Docket Items #4 & #5  
BAR CASE # 2017-00469  
2017-00470

BAR Meeting  
March 7, 2018

**ISSUE:** Partial Demolition & Addition/Alterations

**LOCATION:** 421 North Columbus Street

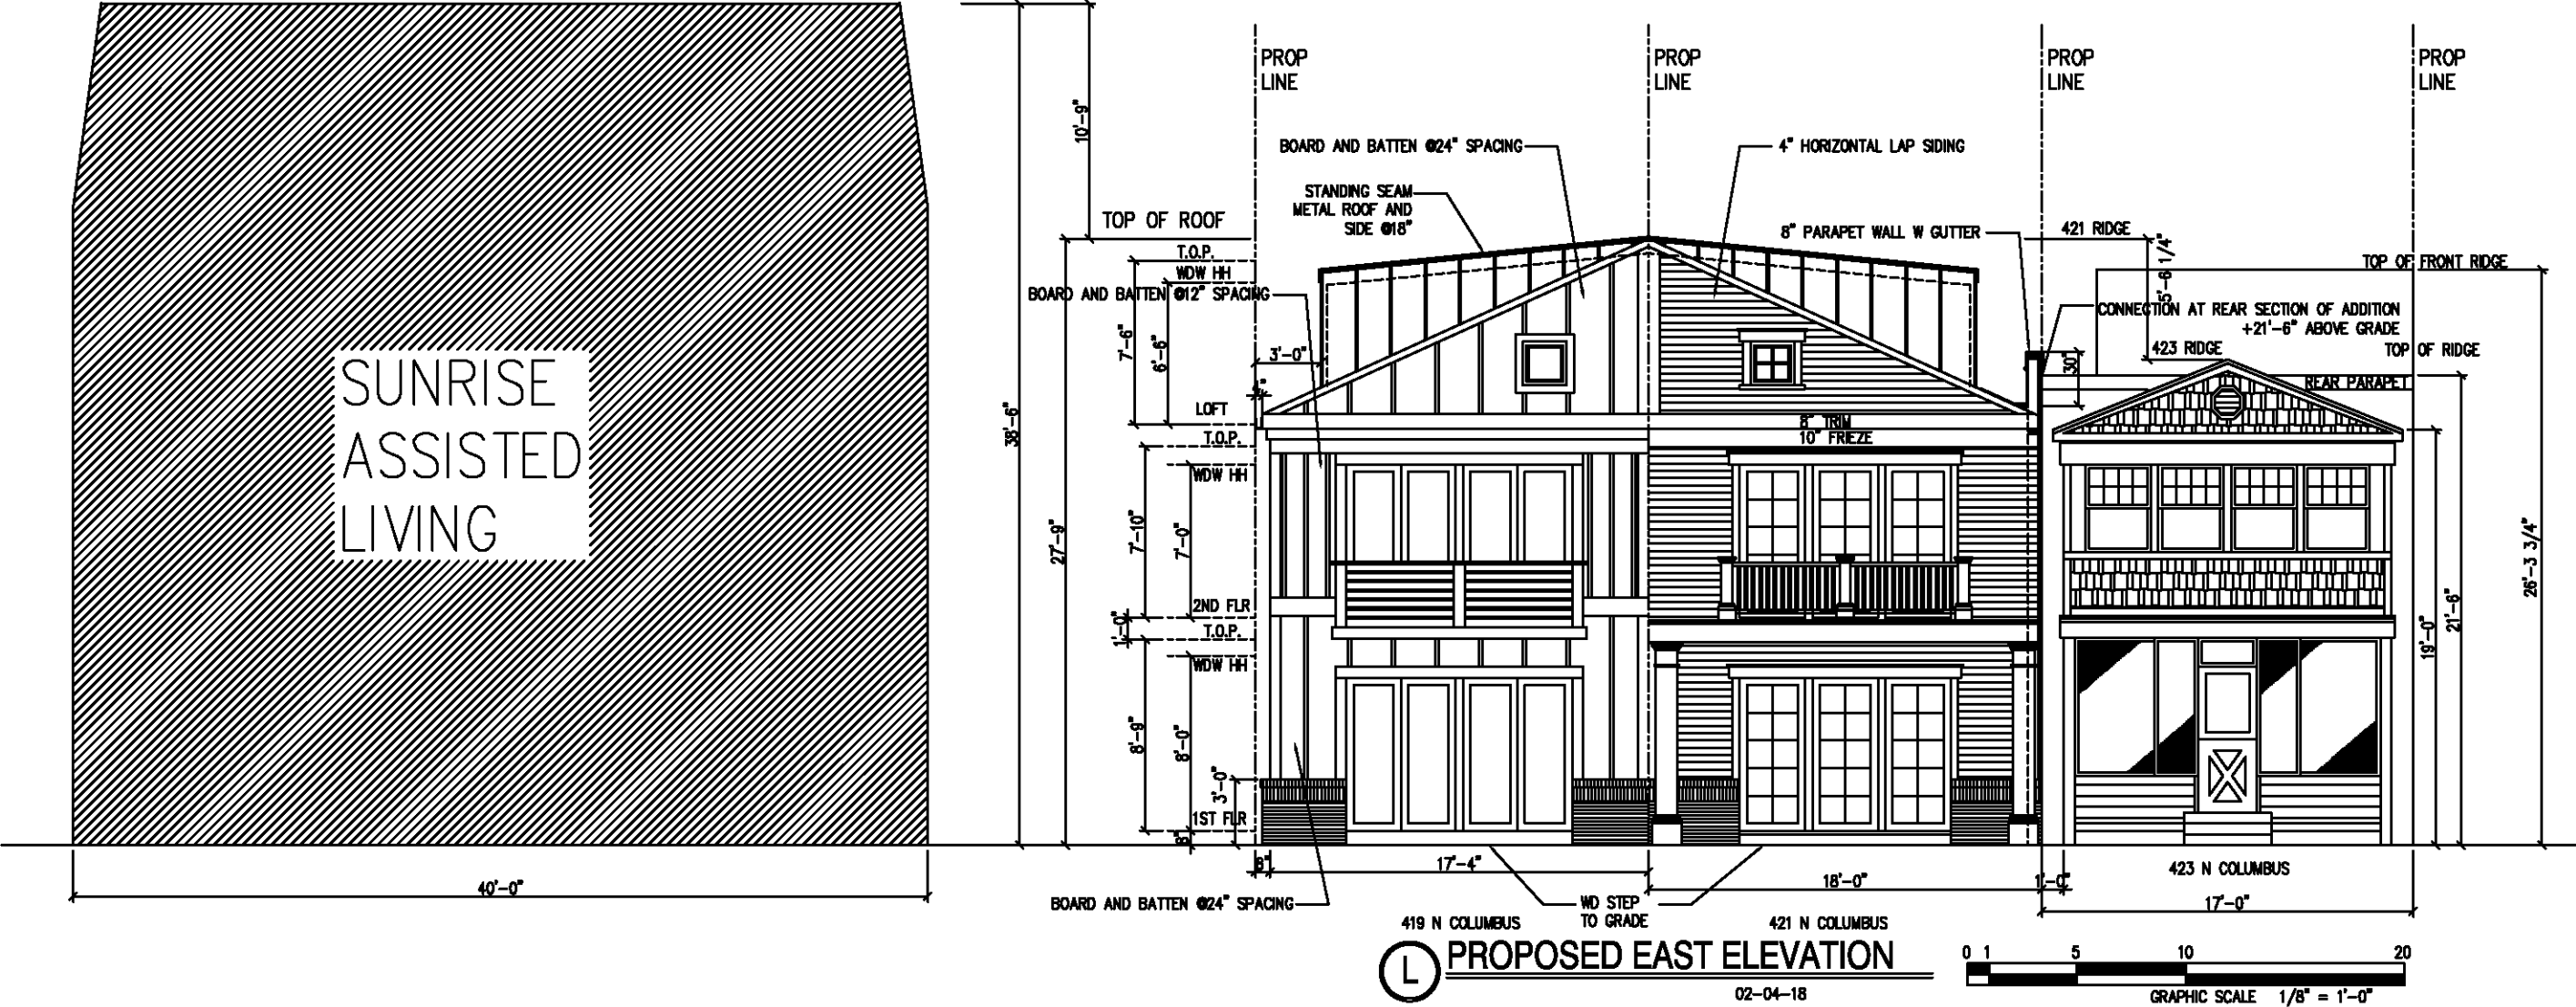
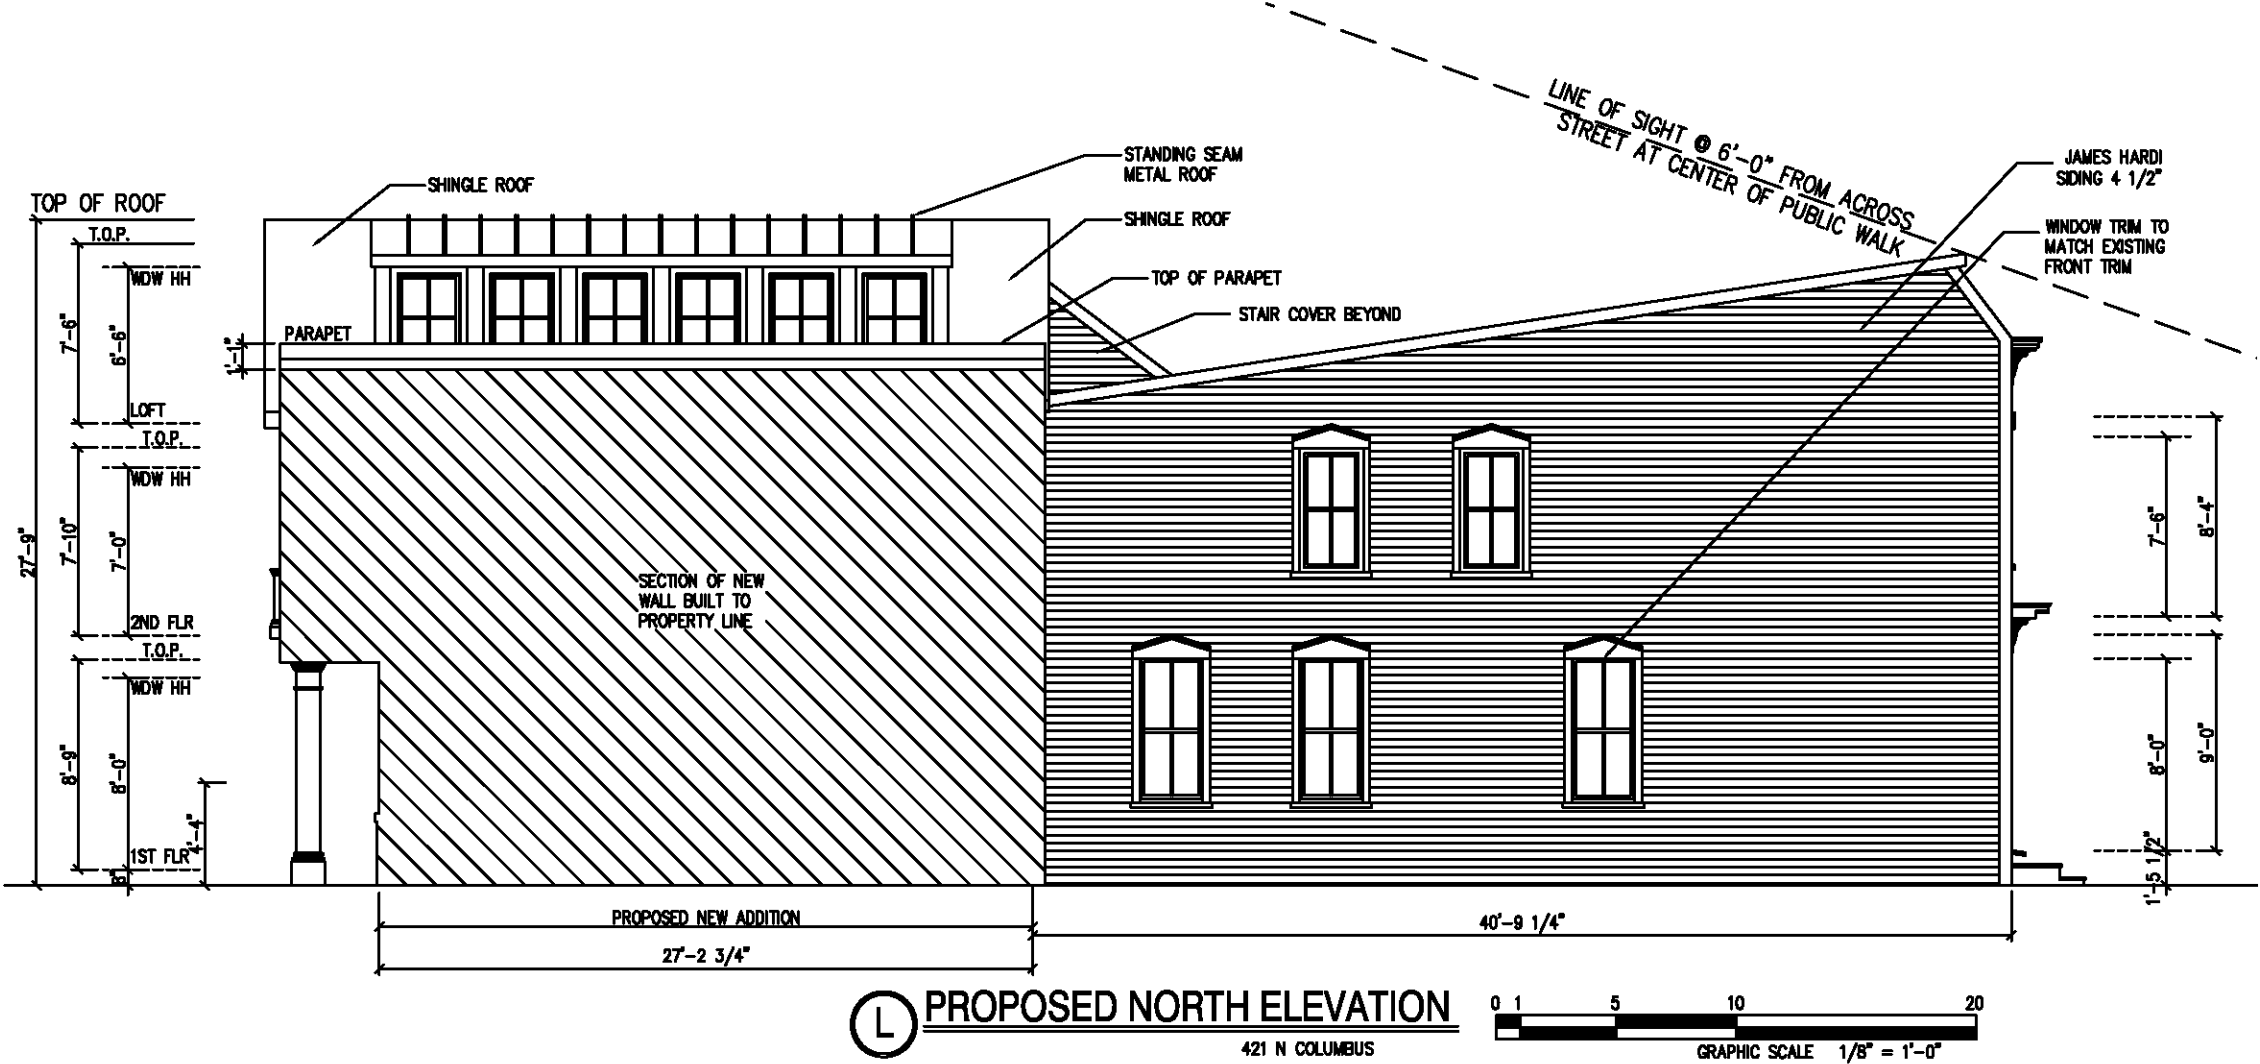
2. The fire separation wall with parapet on the north elevation of the addition should be more integrated and the north elevation should have siding to match the design and profile of the siding on the east elevation.

The renderings show a fire separation wall with a parapet at the north side of 421 adjacent to 423 North Columbus Street. While certainly all building code requirements must be satisfied, staff recommends that this element be refined in order to make the addition more compatible. The north side elevation should have siding similar to the design and profile of the east elevation. Given the limited visibility of this feature from a public way, staff believes that this can be resolved during building permit review with direction provided at the hearing by the BAR.
